Technical Bulletin

/lodel: PR-C1			Dat	te: 29-Jun-07	No.: RD010001	
ubject: ROM History for Engine for PR-C1				Prepared by: Yu	uichiroh Murata	
rom: 1st Tech. Support Sec. Service Support Dept.						
lassification:	Troubleshooting	☐ Part info	orma	tion Actio	on required	
		☐ Electric	al	☐ Serv	rice manual revision	
	Paper path	☐ Transm	it/rec	eive 🗌 Retr	ofit information	
	☐ Product Safety	M Other (\

We hereby inform you of the Engine firmware history for the PR-C1.

P/N D3394451

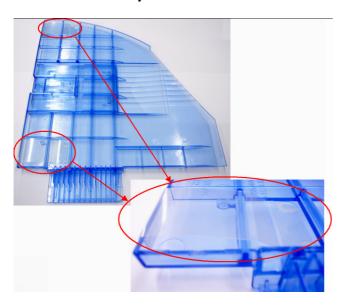
- 1) Two guides (D3394451) were added to the exit tray.
- 2) A guide (D3394452) was added to the lower frame.

Note: The two guides are attached to the underside of the exit tray using double-sided tape.

12.1ST PAPER FEED SECTION (D010/D043)

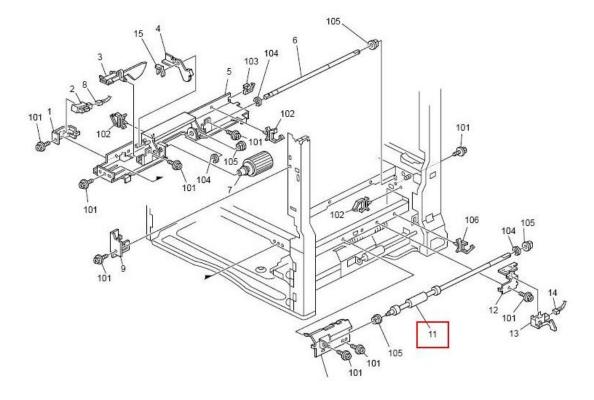
Incorrect P/N	Correct P/N	Description	Q'ty	Int	Page	Index	Note
B0902668	D0102682	Drive Roller - Vertical Transport	1-1	X/O	29	11

Parts catalog correction (The part number and the description were incorrect.)

13.2ND PAPER FEED SECTION 1 (D010/D043)

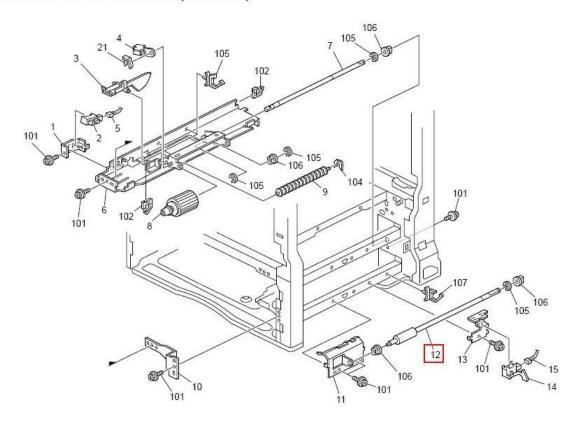
Model: PR-C1		Date: 5-Aug-14			No.: RD010028		
Incorrect P/N	Correct P/N	Description	Q'ty	Int	Page	Index	Note
D0102682	B0902668	Drive Roller - Vertical Transport	1-1	X/O	31	12
